Technical information

OYSTER TUBES AND CROWNS

NEW ASSORTMENT

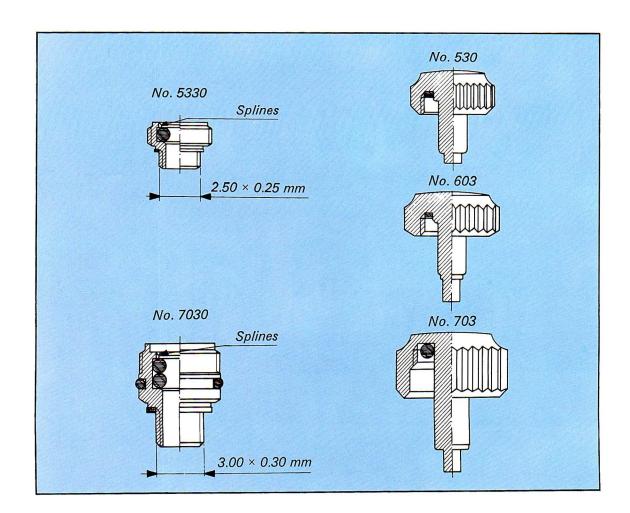
The tubes Nos. 5330 and 7030 with the crowns Nos. 530, 603 and 703 compose the new OYSTER TUBES AND CROWNS assortment.

The tube No. 5330 bears a crown No. 530 or 603 according to the reference of the case. The tube No. 7030 bears a crown No. 703.

The tubes Nos. 5330 and 7030, as also the tube No. 6010, have the splines cut in the crown side part of the tube.

The splines must not be reamed out any longer and can serve for unscrewing.

The new broaches ROLEX Ref. 2095 (22 teeth) and Ref. 2096 (16 teeth) are necessary for fitting these new tubes.

The tube No. 5030 is fitted with a silver washer No. 05310.

The tube No. 7030 is fitted with a Gaco washer No. 06011.

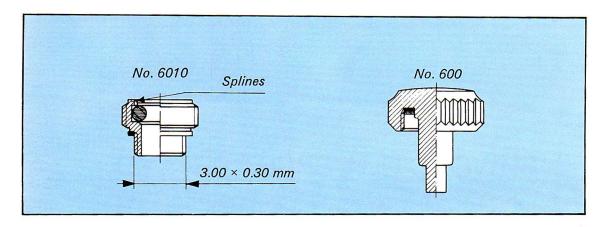
The tube No. 6010 which use is necessary for a transitory period replaces the tube No. 6000 making it possible to equip with a new splined type tube the 6 mm tapped old case bands.

The tube No. 6010 must obligatorily be used with a crown No. 600.

The tube No. 6010 is fitted with a silver washer No. 06020.

OLD ASSORTMENT

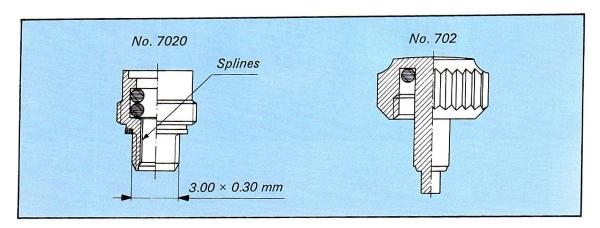
The tube No. 7020 with old type splines must obligatorily bear a crown No. 702; it is fitted with a Gaco washer No. 06011.

The tube No. 8000 and the crowns Nos. 800 and 801 will only be serviceable to the After Sale Service.

The tubes with old type splines Nos. 5300 and 5310 can be replaced by the tube No. 5330, the tube No. 6000 by the tube No. 6010 and the tubes No. 7000, respectively No. 7020, by the tube No. 7030, for as much as the crown No. 700, respectively No. 702, be also replaced by the crown No. 703.
